Project	IEEE 802.16 Broadband Wireless Access Working Group < http://ieee802.org/16 >	
Title	16g-05/008r2 Figure 17c Clean-up	
Date Submitted	2006-01-10	
Source(s)	Lei Wang Cygnus Communications Inc.	Voice: 760-448-4168 Fax: 760-448-1989 lwang@cygnuscom.com
Re:	This is a part of the 16g working document restructure/clean-up editing work.	
Abstract	As discussed in 802.16g 2005-November meeting, the 16g working document 16g-05/008r2 needs to be restructured and cleaned-up. This contribution attempts to clean up Figure 17c.	
Purpose	The purpose of this contribution is to clean up Figure 17c.	
Notice	This document has been prepared to assist IEEE 802.16. It is offered as a basis for discussion and is not binding on the contributing individual(s) or organization(s). The material in this document is subject to change in form and content after further study. The contributor(s) reserve(s) the right to add, amend or withdraw material contained herein.

16g-05/008r2 Figure 17c Clean-up

Figure 17c: GPCS Layering Model

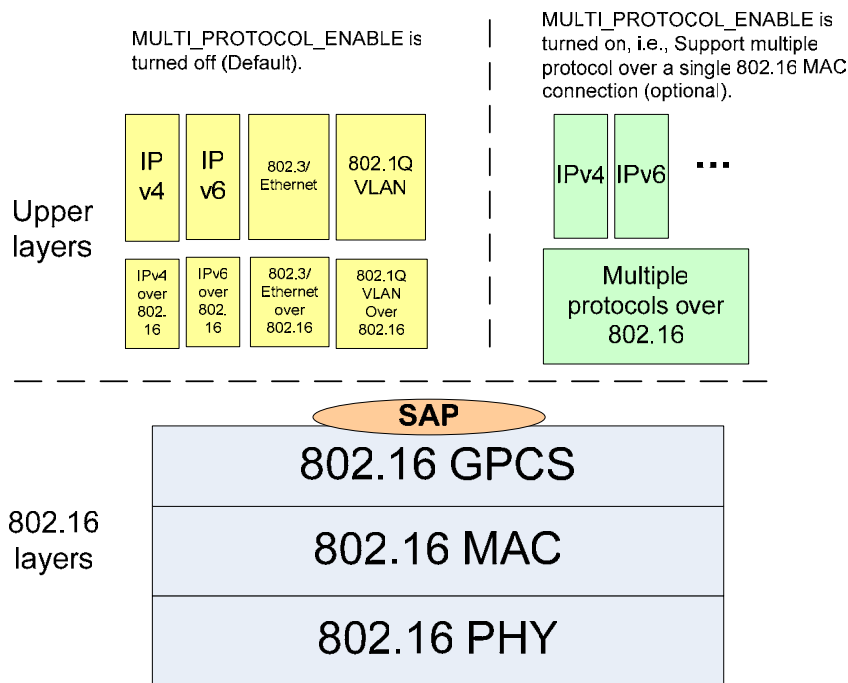
1. page 3 replace Figure 17c by the following:

Protocol structure with the proposed Generic Packet Convergence Sublayer (GPCS)
